1 Dear Anonymous Referee #2,

23 The manuscript entitled, "Segmented Gurney Flaps for Enhanced Wind Turbine  
24 Wake Recovery" by Nirav Dangi, Koen Boorsma, Edwin Bot, Wim Bierbooms, and  
25 Wei Yu endeavors to describe differences in wind, turbine wake aerodynamics  
26 introduced by the presence of a gurney flaps. On the trailing edges of wind turbine  
27 Blade tips. There is a long history of flaps as passive or active control, mechanisms  
28 for wind, turbines, and a great deal of debate in the literature as to their merit. The  
29 authors are strongly encouraged to review this literature and contextualize their  
30 work within the spotty before presenting this for publication again.

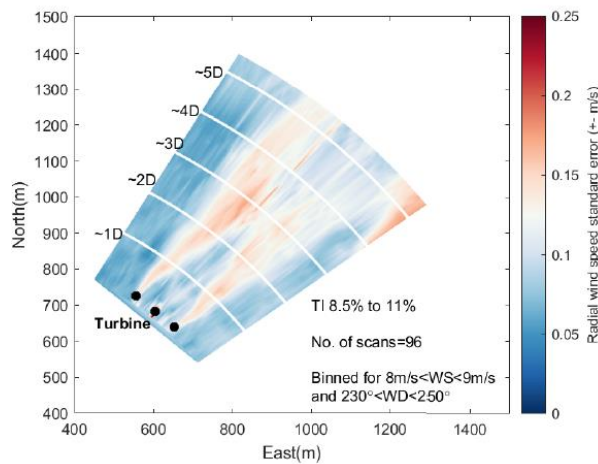
71 This sort of hard filtering based on CNR may be overly conservative and reject viable  
72 data or overly generous and keep outliers or spurious data. The dynamic procedure  
73 proposed by Beck and Kuhn (2017) offers a more localized approach to filtering and  
74 is more likely to provide better flow estimates.

75 Thank you for the suggestion- this is out of scope of the study at this stage, and will  
76 be added as a recommendation for future work. Previous studies which incorporate  
77 the hard CNR filter were included in the manuscript. Below is another reference for  
78 the same:

82 Nevertheless, we believe in the robustness of the results with the post processing  
83 chain used. The standard error is indicated below for the hub height for one of the  
84 results (Figure 11a). Overall the standard error is quite low and as expected, typically  
85 around the wake edges it is higher because of probe volume averaging in the region  
86 of wake interaction with the freestream.
